Access Compliance Report

Public Rights-of-Way

Intersection ID: 16155	Main Street: DEWITT_LN	Cross Street: TRYCLAN_DR	Location: NW
ADA ID: 601851A2ADB6	Ramp Type: PerpDiag	Initial Pass/Fail: Fail	Overall Compliance: No
		Severity Score: 8.75

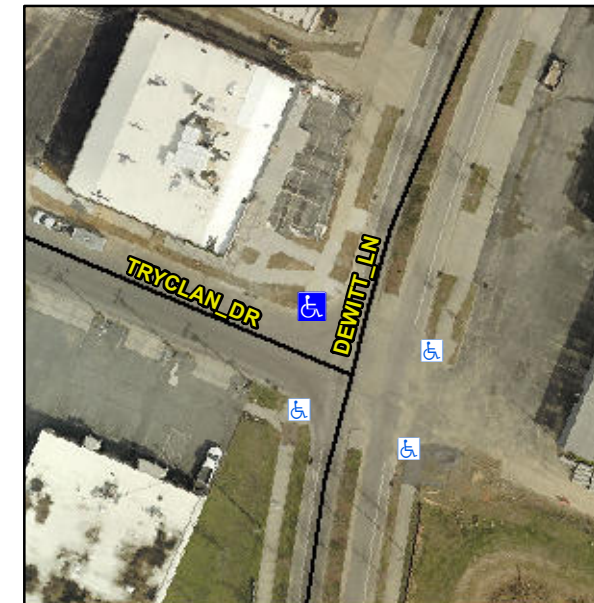
Not Found, R304.5.1

Compliance	Description	Data	Compliance	Description	Data
N/A	Ramp Length (in)	95.0	Yes	Ramp Slope (%)	6.7
No	Ramp Width (in)	45.0	Yes	Ramp XSlope (%)	0.6
N/A	Flare Type LT	N/A	N/A	Flare Type RT	N/A
N/A	Flare Slope LT (%)	N/A	N/A	Flare Slope RT (%)	N/A
N/A	Flare Traversable LT?	N/A	N/A	Flare Traversable RT?	N/A
N/A	Landing Length (in)	N/A	N/A	DWS Provided?	N/A
N/A	Landing Width (in)	N/A	N/A	DWS Contrast?	N/A
N/A	Landing Slope (%)	N/A	N/A	DWS Length (in)	N/A
N/A	Landing X Slope (%)	N/A	N/A	DWS Full Width?	N/A
N/A	Landing Curb? (Y/N)	N/A	N/A	DWS Offset (in)	N/A
N/A	Shared Landing?	N/A			
N/A	Gutter Ponding?	N/A	N/A	Gutter Slope (%)	N/A
N/A	Gutter Lip Ht (in)	N/A	N/A	Gutter X Slope (%)	N/A
N/A	Painted X Walk1?	No	N/A	Painted X Walk2?	No
	X Walk 1 Direction	To S		X Walk 2 Direction	To SE
N/A	X Walk 1 Width (in)	N/A	N/A	X Walk 2 Width (in)	N/A
	X Walk 1 Slope (%)	2.1		X Walk 2 Slope (%)	1.7
	X Walk 1 X Slope (%)	1.3		X Walk 2 X Slope (%)	1.1

Remove & Replace Curb Ramp With Two New Directional Ramps or Equivalent.
